TAYLOR ESTATES SUBDIVISION, RESUBDIVISION OF AND ADDITION TO LOT 1

APPLICATION NUMBER 14 DATE May 21, 2009

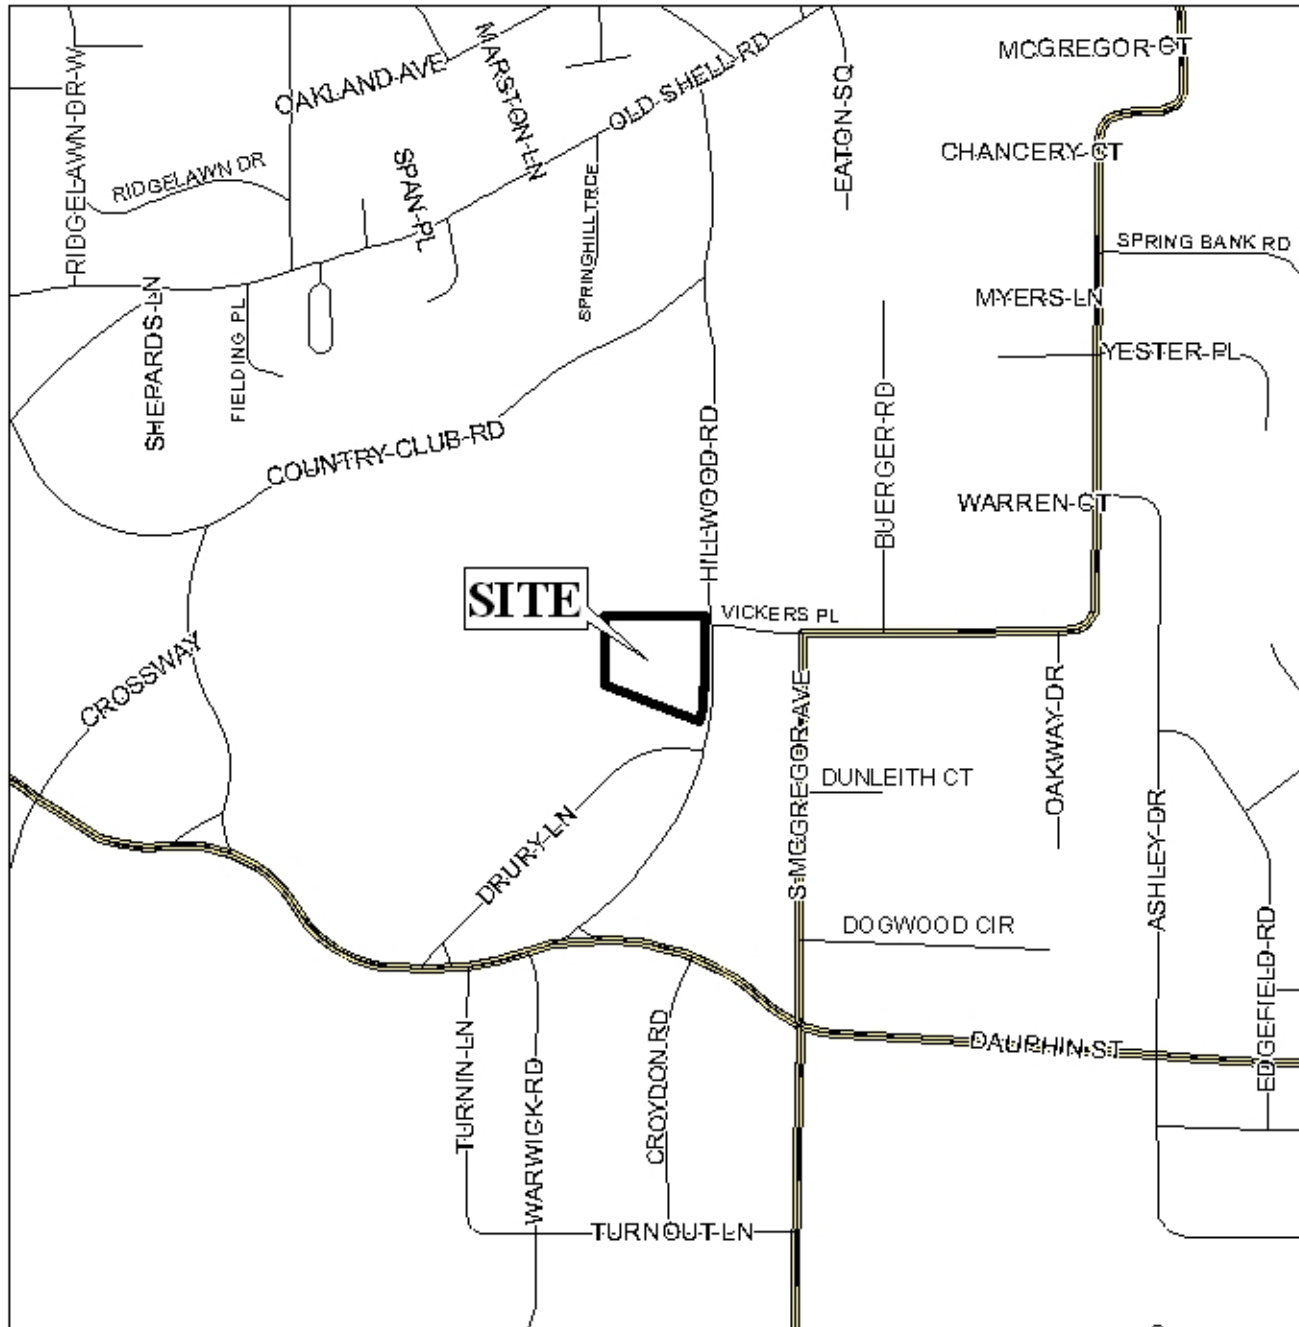
The proposed subdivision has frontage on Hillwood Road with a variable right-of-way. As no dedication was required with the approval of Taylor Estates Subdivision in 2004, none should be required in this case. The plat illustrates the 25' minimum building setback line along Hillwood Road and this should also be shown on the final plat. As a means of access management, a note should be required on the final plat stating that each lot is limited to one curb cut to Hillwood Road, with the size, location, and design to be approved by Traffic Engineering and conform to AASHTO standards.

Each lot is labeled on the plat with its size in square feet, and should also be so-labeled on the final plat, or a table should be provided furnishing the same information.

Proposed Lot 2A currently contains a dwelling; therefore, the plat should be revised to indicate the resultant side yard setbacks off the dwelling to be compliant with a minimum setback on one side of at least 8', and at least 12' on the other side, to provide a minimum combined side yard total of 20'.

- 1) illustration of the 25' minimum building setback line along Hillwood Road;
- 2) placement of a note on the final plat stating that each lot is limited to one curb cut to Hillwood Road, with the size, location, and design to be approved by Traffic Engineering and conform to AASHTO standards;

- 3) labeling of each lot with its size in square feet, or the provision of a table on the final plat furnishing the same information;
- 4) placement of a note on the final plat stating that development of the site must be undertaken in compliance with all local, state and Federal regulations regarding endangered, threatened or otherwise protected species;

- 5) illustration of the resultant side yard setbacks for the existing dwelling on proposed Lot 2A to be compliant at 8' and 12' minimums, and with a total combined width of at least 20'; and
